# **CONNECTION ASSESSMENT & APPROVAL PROCESS ASSESSMENT SUMMARY**

**Project: Coniston TS – Modify Station to Separate  
Transmission and Generation Assets**

**CAA ID: 2002 – EX095**

**Date: December 18, 2002**

Figure 2: Coniston TS - Proposed Plan

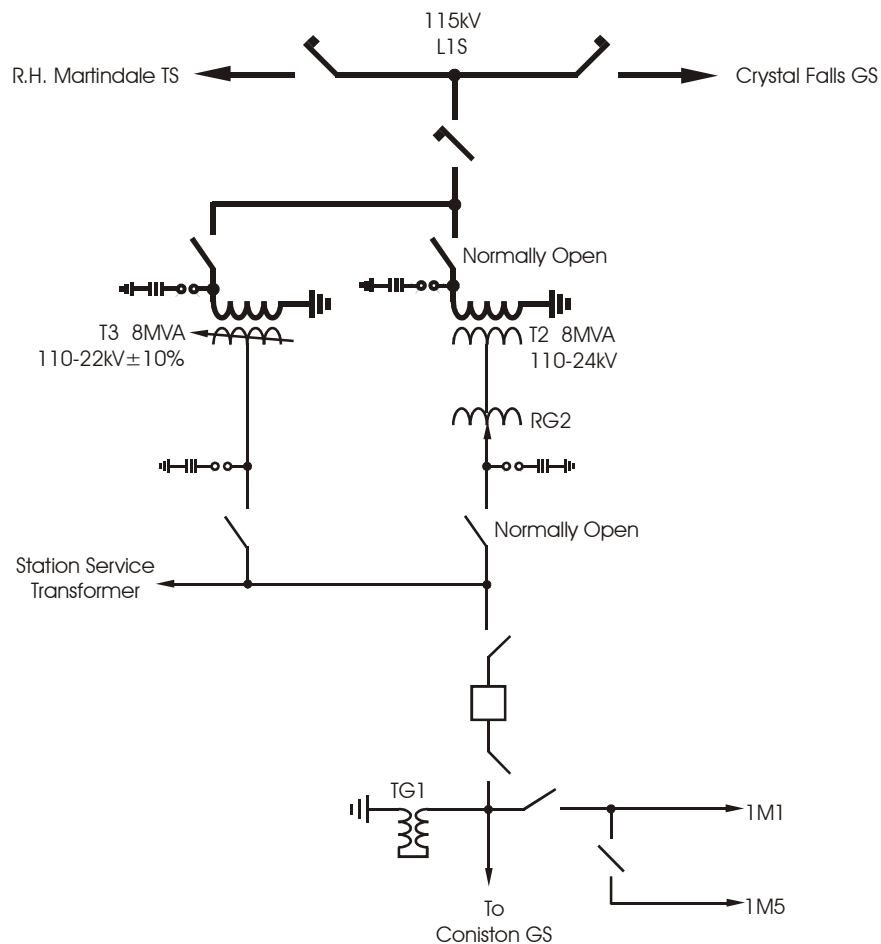
The proposed replacement of the existing rod gaps with metal oxide surge arresters will bring the surge protection facilities to the existing industrial standards, resulting in better reliability. However, it should be noted that the proposal to terminate both 22kV feeders onto a single feeder position and connecting the embedded Coniston GS via the same low voltage breaker would lower the reliability of the two feeders and the generating station.

The two feeders and Coniston GS are presently terminated at the 22kV ring bus, such that any fault on one feeder will not affect the other feeder or the generating station unless breaker failure occurs. The proposal will have both 22kV feeders and Coniston GS terminated onto a single feeder position (Figure 2). Any fault on either feeder will take both feeders and Coniston GS out of service until the faulted feeder can be isolated by opening the feeder disconnect switch.
